**SECTION 00 9111 - ADDENDUM NUMBER 1**

**1.01 DATE: SEPTEMBER 16, 2016**

**1.02 PROJECT: GENERAL CONSTRUCTION INDEFINITE DELIVERY CONTRACT (MCKISSICK MUSEUM BATHROOM RENOVATIONS)**

**1.03 OWNER'S PROJECT NUMBER: H27-D259-CB**

**ALTERNATE #1 - ENLARGED RENOVATION PLAN - SECOND FLOOR MENS ROOM**  
1/4"=1'-0"

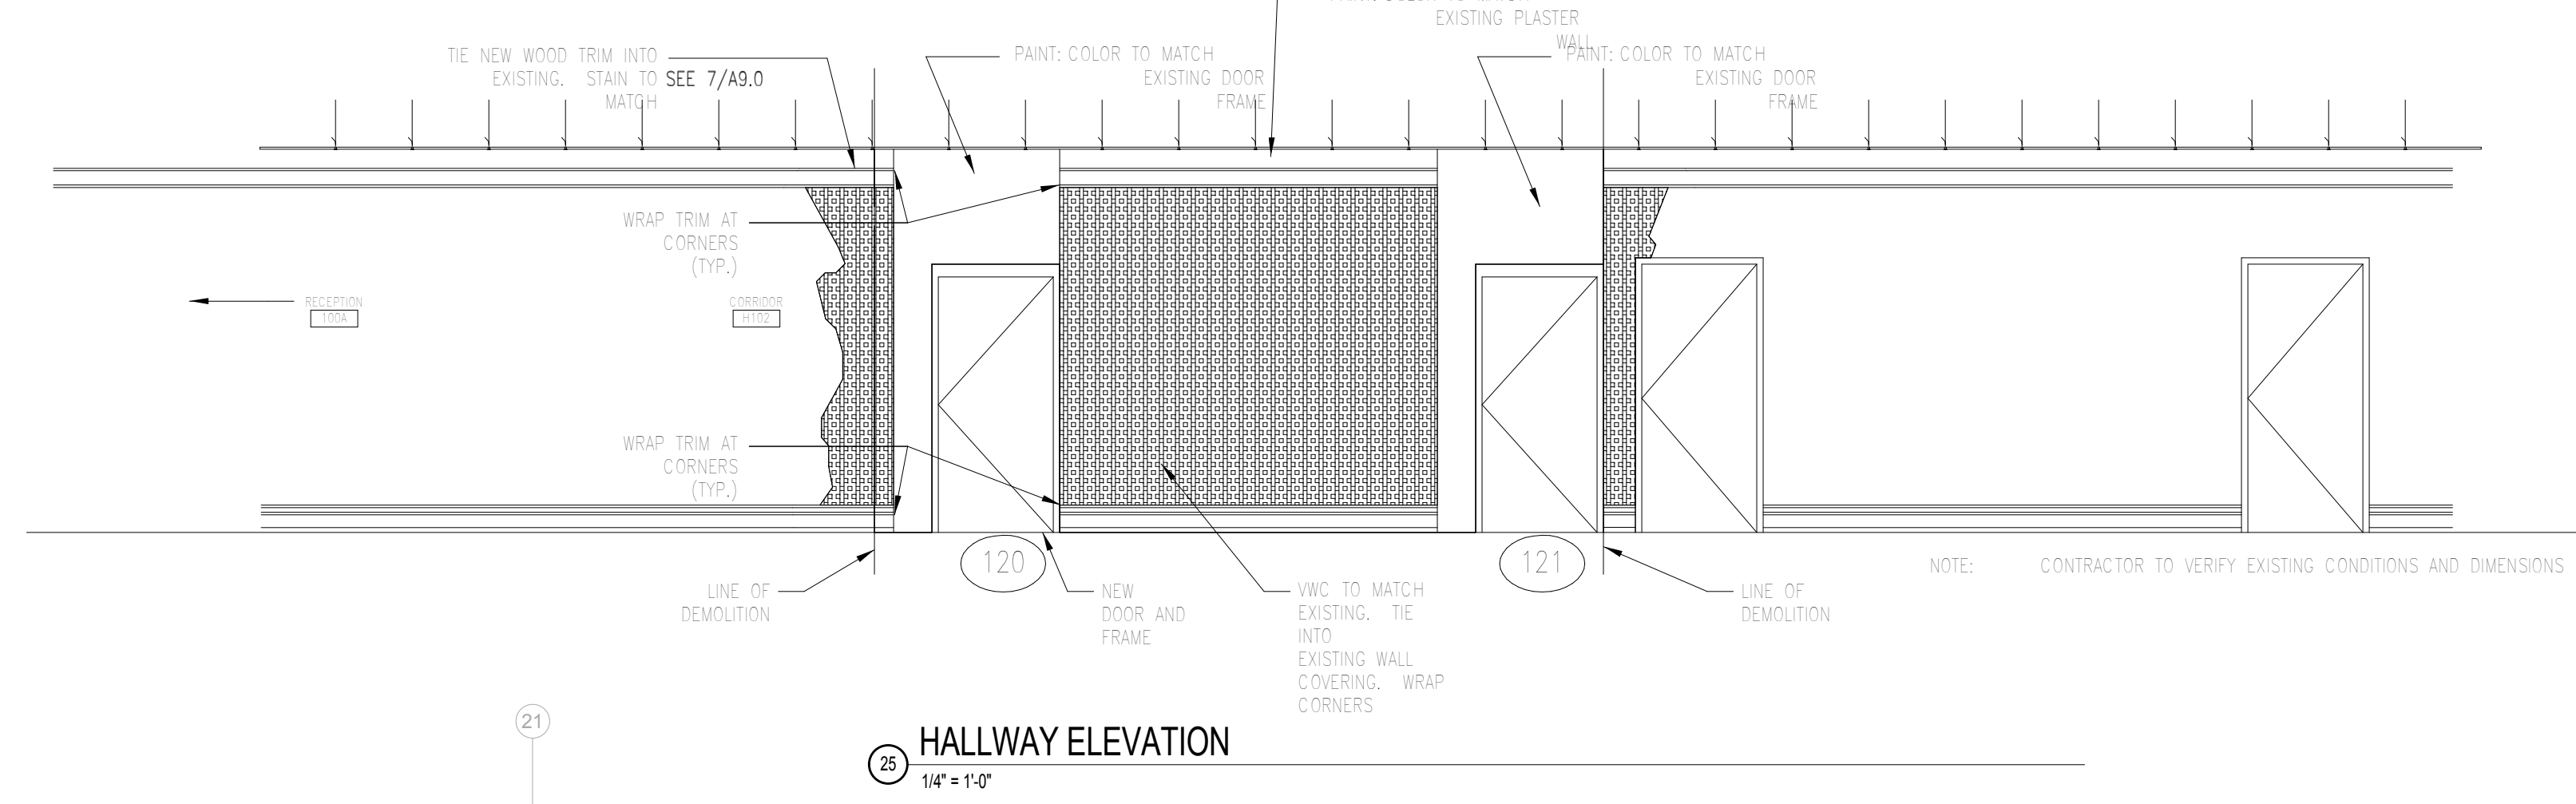
- A. Replace existing drawing A6.0 with the revised drawing A6.0 attached.
- B. Deleted drawing 15, 16, 17, 18, 19, 20, 21, 22, 23, & 24/A6.0 from the scope of work.
- C. Deleted rooms Mens 209 and Womens 210 from the Finish Schedule and from the scope of work.

3 ALTERNATE #1 - ENLARGED SECOND  
FLOOR - WOMENS ROOM  
1/4"=1'-0"

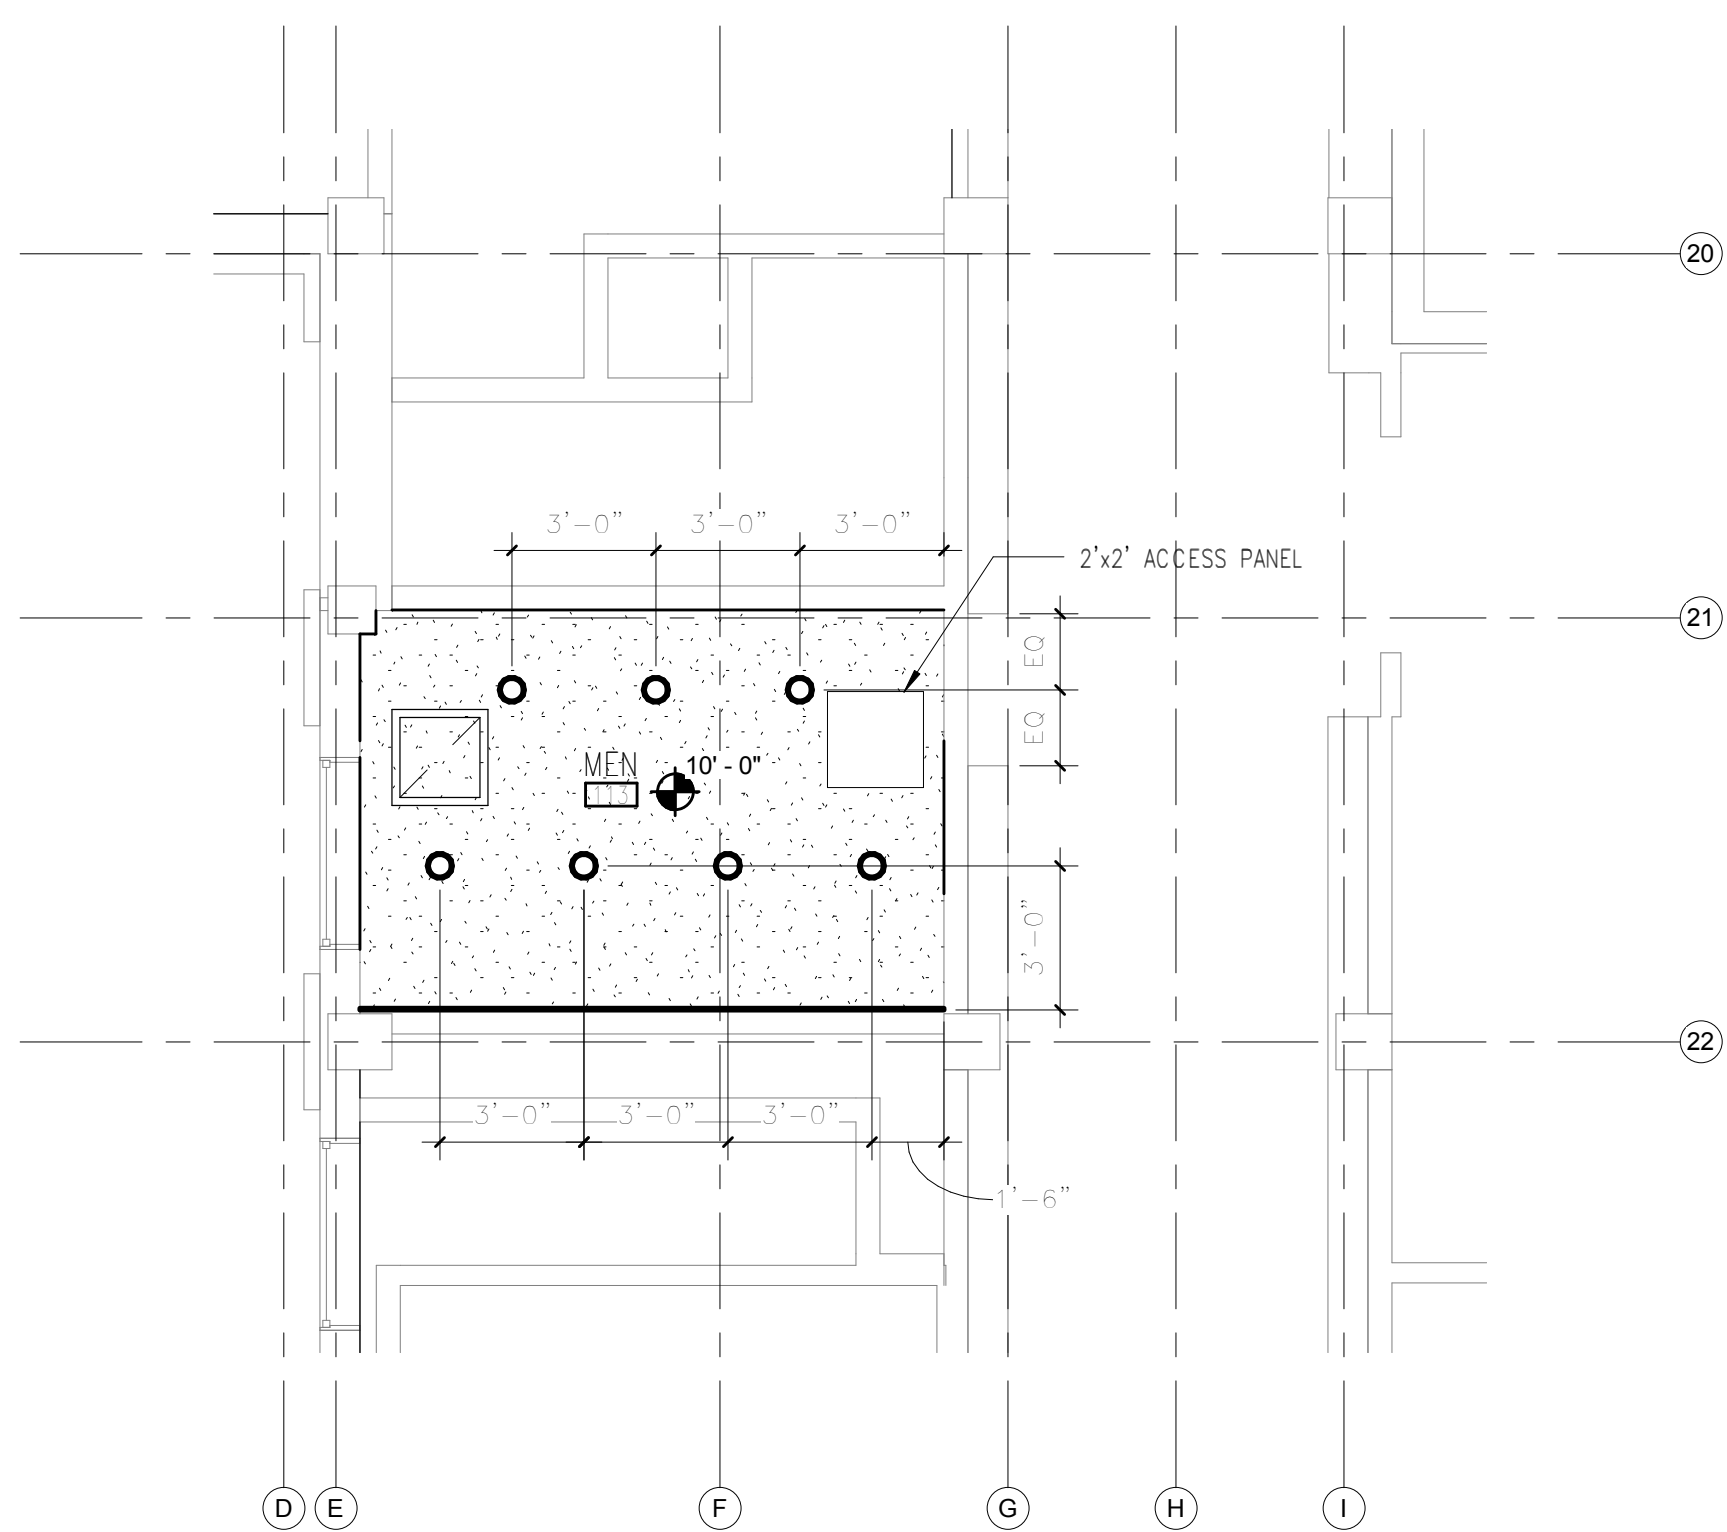
- A. Replace existing drawing A7.0 with the revised drawing A7.0 attached.
- B. Deleted drawing 3 & 4/A7.0 from the scope of work.
